Access Compliance Report Public Rights-of-Way (RR Crossings)

Intersection ID: 10038385	Main Street: SOUTH_BV	Location: N/A
ADA ID: F667D541EC0D	Overall Compliance: No	Severity Score: 0.0
Codes/Mitigation Info/Possible Solution		Field Measurements/Component Compliance

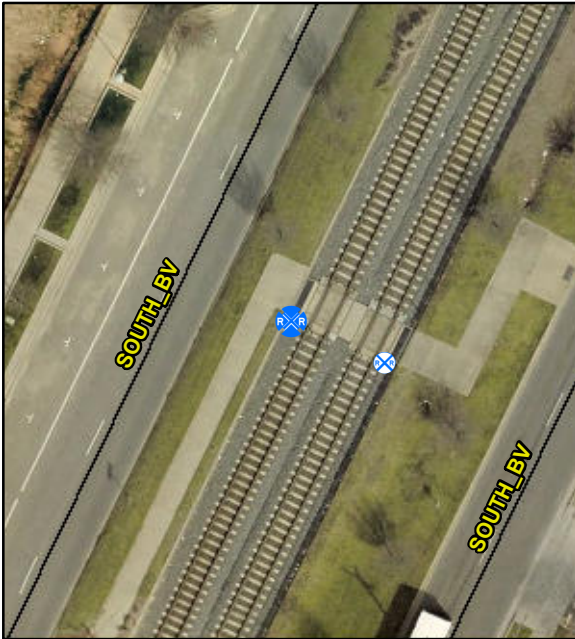
**Remove & Replace Detectable
Warning System. Provide Pedestrian
Gate. Remove & Replace Walking
Surface Adjacent to Rail.**

R302.7.4, R305.2.5

Compliance	Description	Data
Yes	DWS Provided?	Yes
Yes	DWS Contrast?	Yes
Yes	DWS Width (in)	Yes
Yes	DWS Length (in)	25.0
No	DWS Offset (in)	13.0
No	Pedestrian Gate?	No
N/A	DWS Outside Gate?	N/A
N/A	Rail Type?	LightRail
No	Flangeway Gap (in)	3.0
Yes	Sidewalk Width (in)	151.0
